## SWINGING BRIDGE DAM

SULLIVAN COUNTY, NEW YORK

INVENTORY NO. N.Y. 696

### 6 PHASE I INSPECTION REPORT NATIONAL DAM SAFETY PROGRAM

Spillway Flood Gate  
Note Deteriorated Concrete Slab  
Photo #17

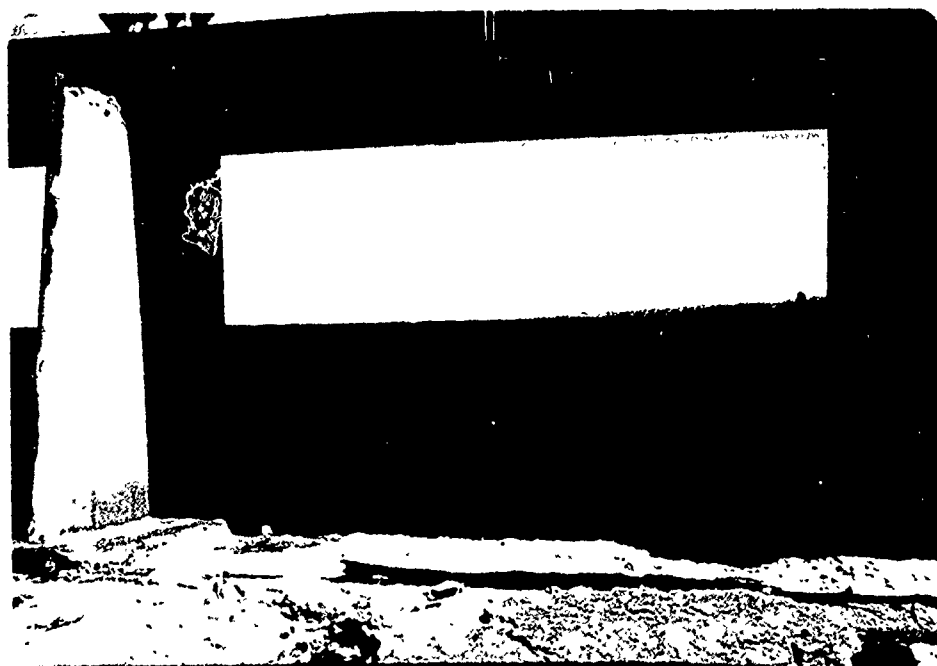
2. Structural cracking of the gate tower (reportedly due to ice loading) and deterioration of the spillway slabs and flood gate supports was noted. Investigation of these conditions must be completed within 1 year of notification and repairs completed within the next construction season.

Considerable concrete spalling and deterioration was observed on the flood gate supports and the spillway slabs. In certain areas, the spalling has progressed to the point where reinforcing bars are exposed. This spalling appears to be related to exposed surfaces where ice and water have initiated deterioration. Leaking of flashboards was also noted. Considerable tree growth was observed in the tailrace channel and along the channel slopes. The flood gate system was reported to be operational.
